Cordillera Valley Club

Design Review Board

Rubin Residence - Addition and Deviation to an Existing Residence

Sierra Valley Cl **ign Review Boa** *aff Memorandum*

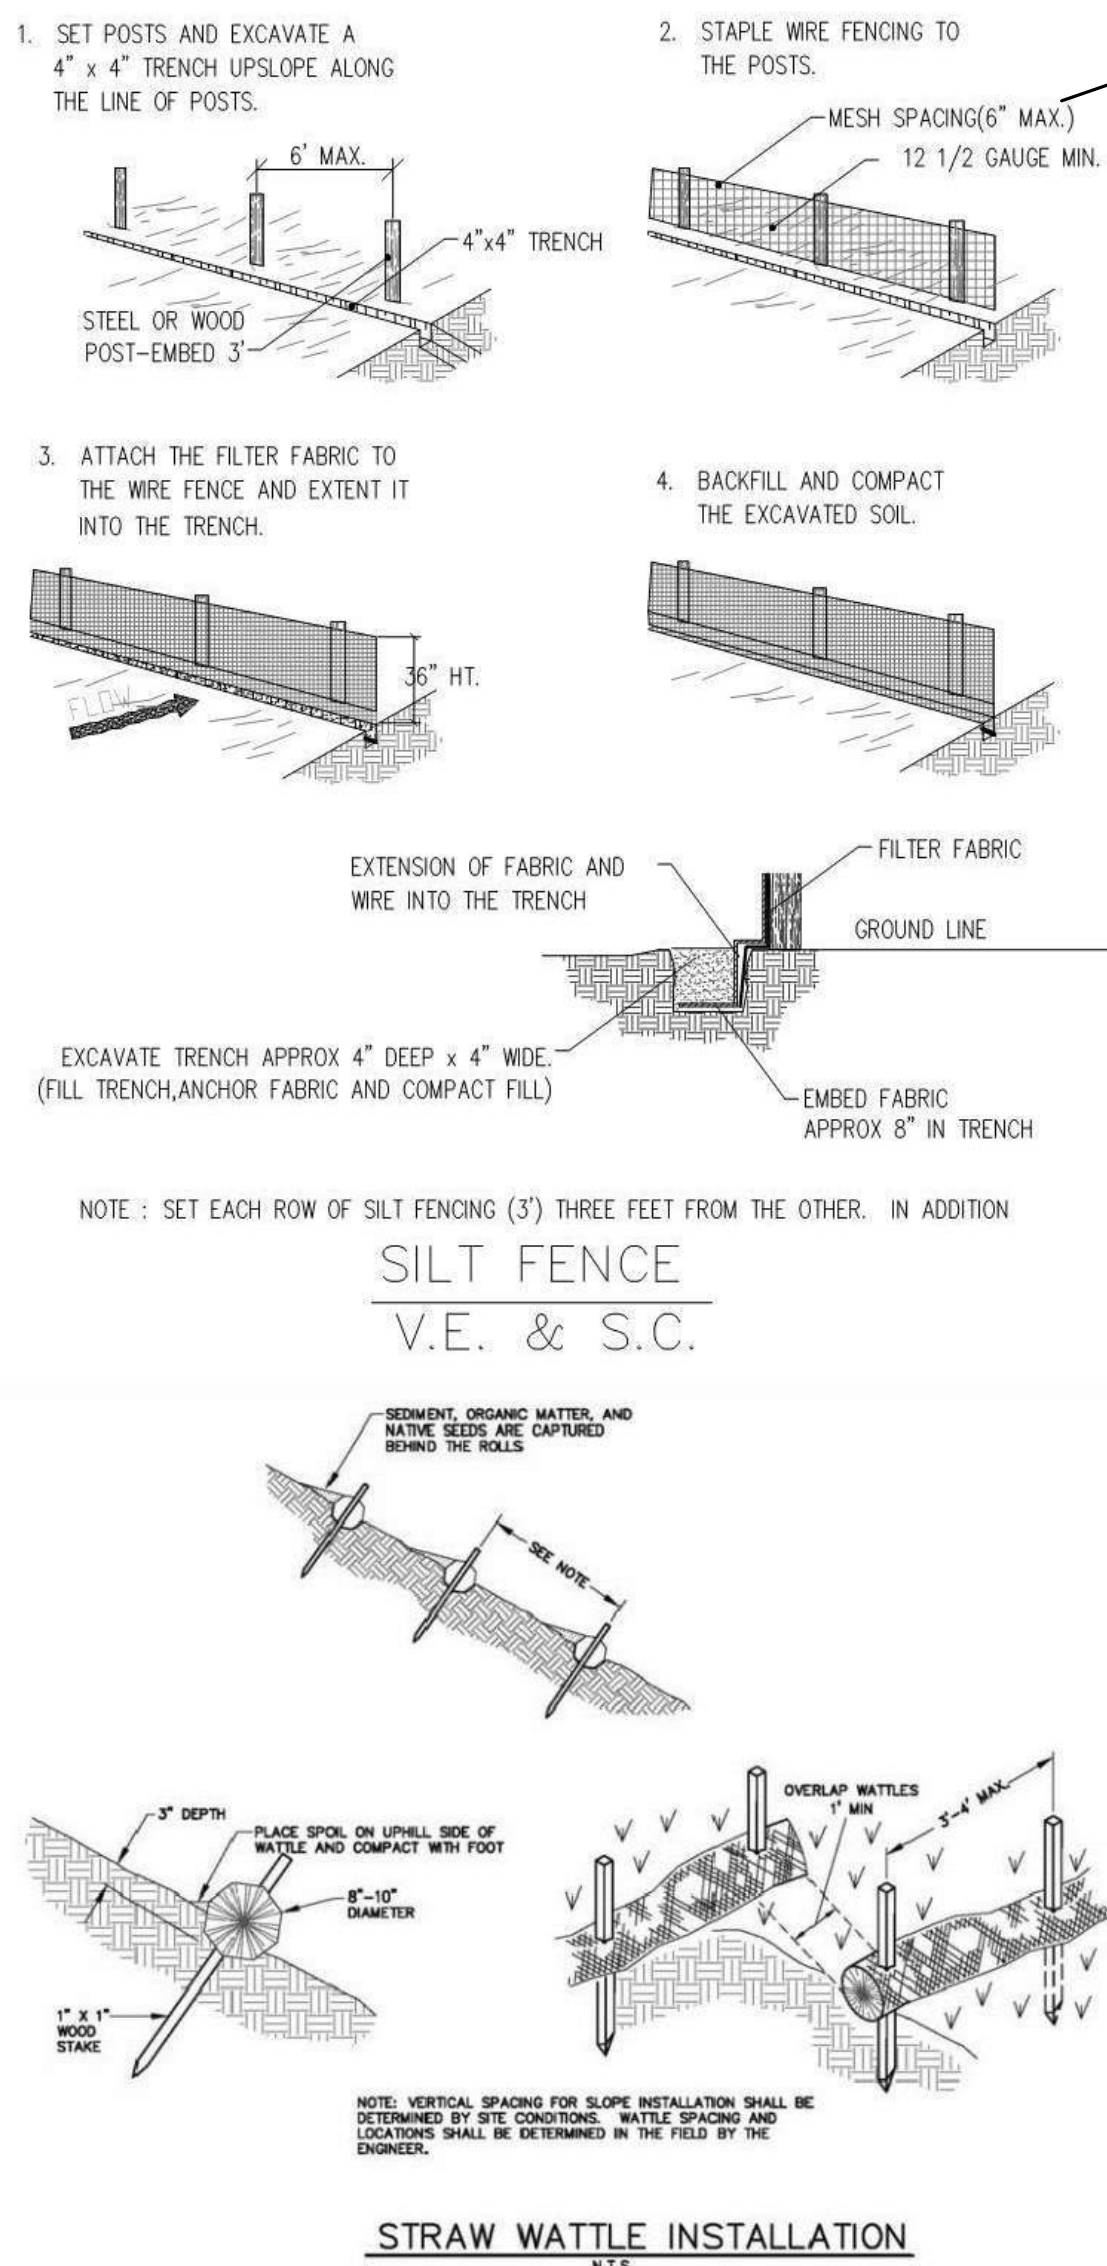
Jeff ran through the plans. He showed the revisions to plans. He requested that the project be broken into two parts. He showed opportunities to fix portions of the wall and add landscaping. He talked through construction access options.

Jeff Embry stated he was fine with allowing access to occur through his property as long as the new aspens could be avoided. He stated he was fine with the encroachment into the building envelope and asked about timing.

AGREEMENT WITH EAST NEIGHBOR TO CROSS PROPERTY IS TO BE FORMALIZED. SHOULD BE ABLE TO ACCESS WITH MINIMAL TREE/SITE DISTURBANCE. REVEG ALL DISTURBED AREAS TO BETTER THAN EXISTING CONDITIONS.

2 NORTH ELEVATION
1/4" = 1'-0"

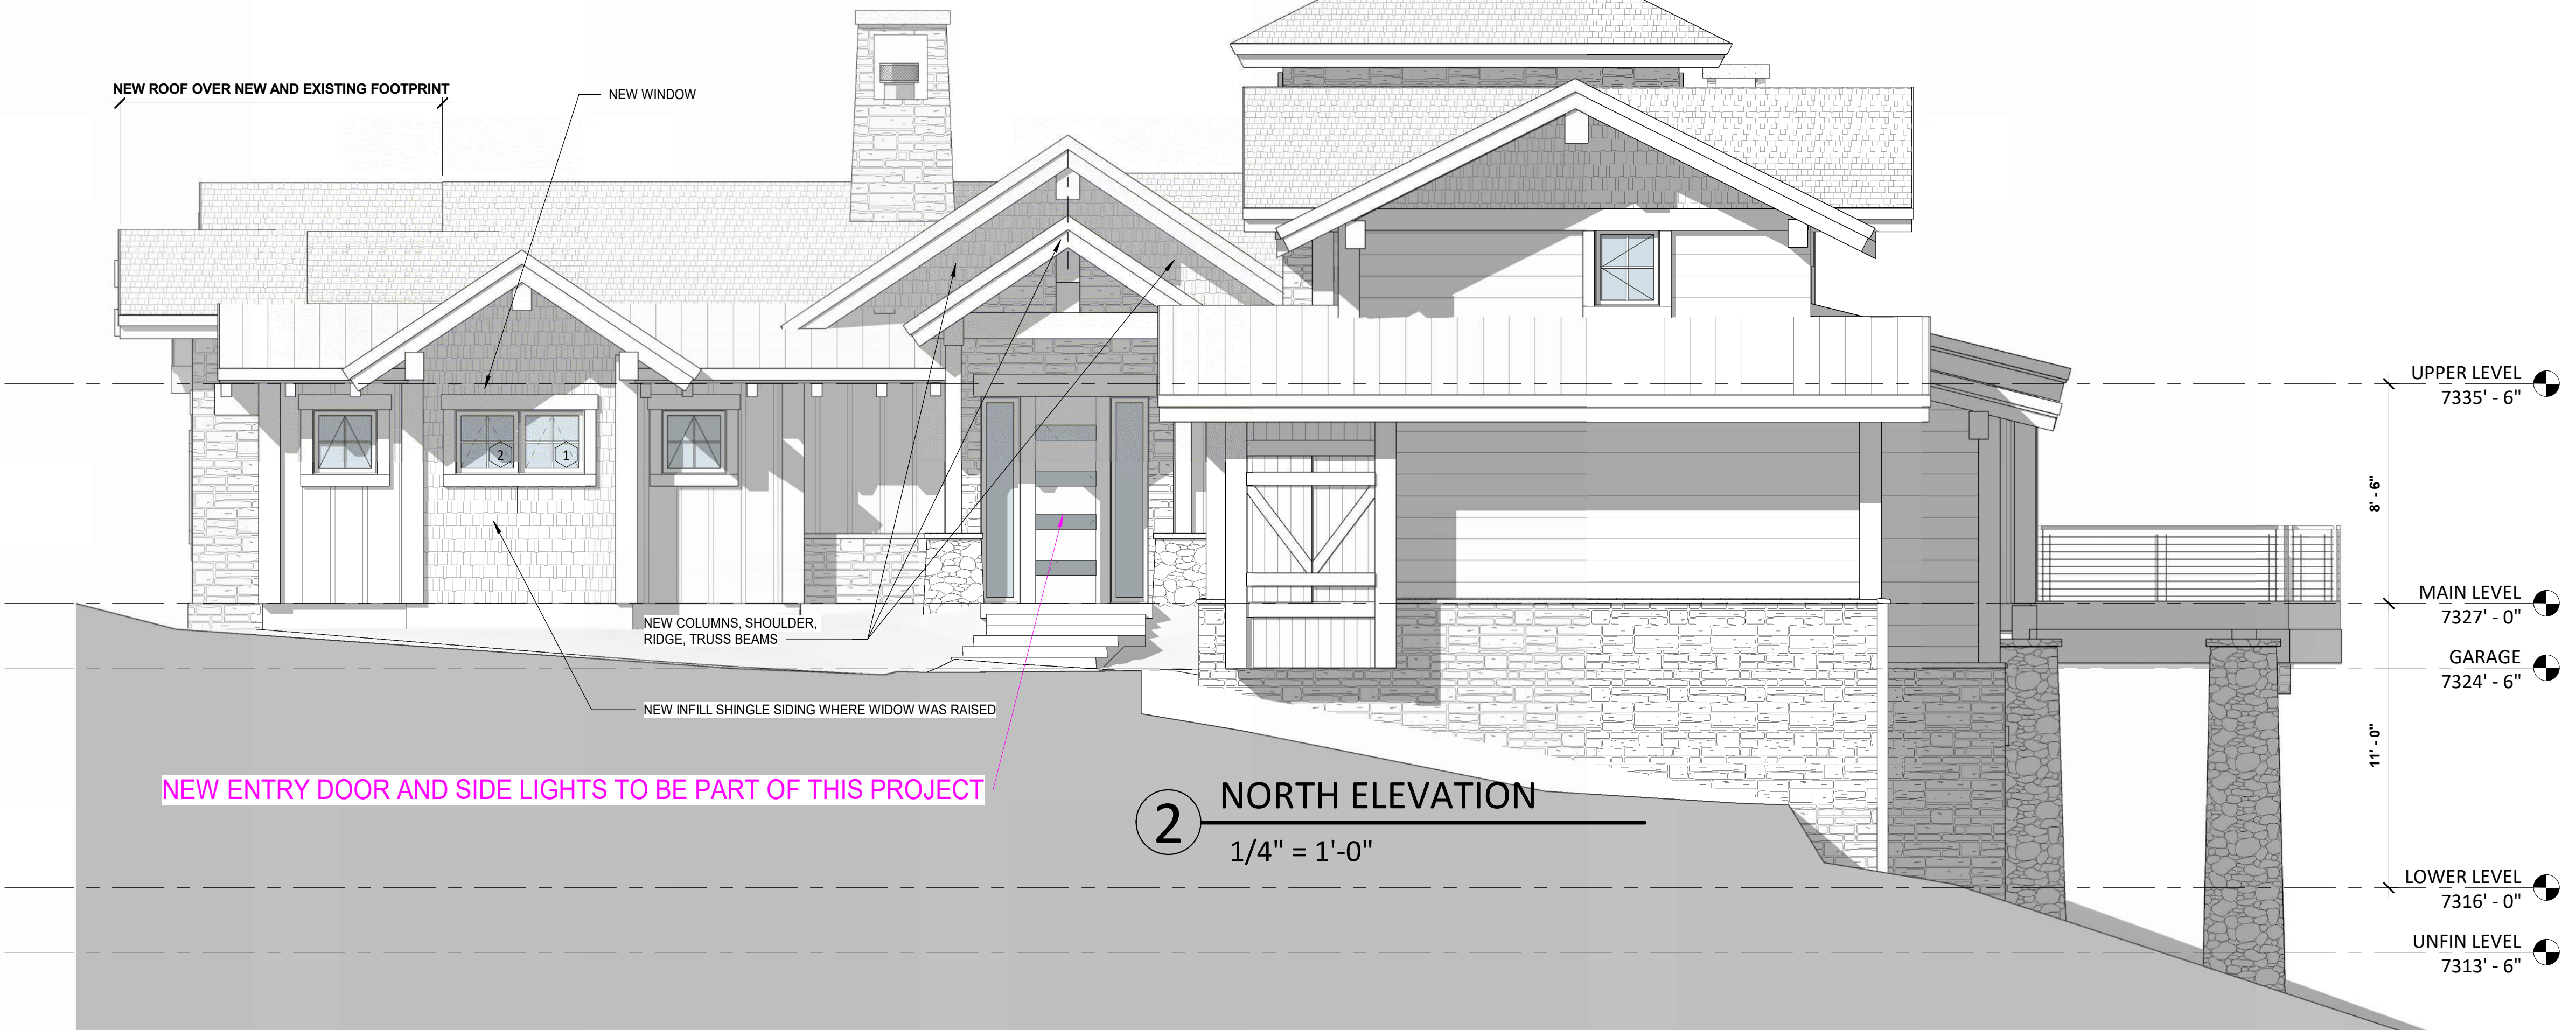
1. Due to the size of the proposed deck and the proximity to the property line and ravine below, the impact of the deck expansion is dramatic. The new stone columns are 14 ft. tall. The Design Guidelines state: *“Balconies and above grade decks should be designed within the mass of the building or as an element of the building structure supported either by angled braces, by building mass below, or by substantial building elements such as stone columns that visibly tie the deck to the ground. In no case shall projecting decks or balconies be supported by narrow posts or columns. Projected decks on the downhill side of the building shall be tied into the existing grade, helping integrate them with the natural grade of the site. Support columns must have stone bases with dimensions consistent with the massing of the home. The underside of balconies and above grade decks shall be finished to be compatible with the building. Consideration should be given to protecting balconies and above grade decks from snow shedding from overhead roofs.”* Staff recommends the DRB provide input on the proposed deck expansion.

Bobby stated that not only were there a lot of columns, the columns are massive. He asked the architect to look at cantilevering them so that the number of them could be reduced. He had no issues with the addition or any of the other changes such as doors and windows. He stated that they needed to figure out a plan for the other area and that it was an unfortunate situation. He was ok with dealing with the issues separately.

Michael agreed with Bobby. He said the number of columns needed to be reduced. Otherwise, the addition itself looked good.

1. Based on the DRB's input from the previous meeting, the applicant has made the following changes:
 1. Created variation along the edge of the deck to reduce the boxy mass
 2. The stone columns have been tucked under the deck
 3. An aspen tree has been added on the west side and created a more robust landscape plan.
2. At the previous meeting, the DRB stated that the number of columns for the deck needed to be reduced. Staff believes that the variation along the edge of the deck is helpful, but the number of columns remains a concern. The DRB should provide input on the deck design.
3. Generally, staff believes all other proposed improvements are consistent with the Design Guidelines.
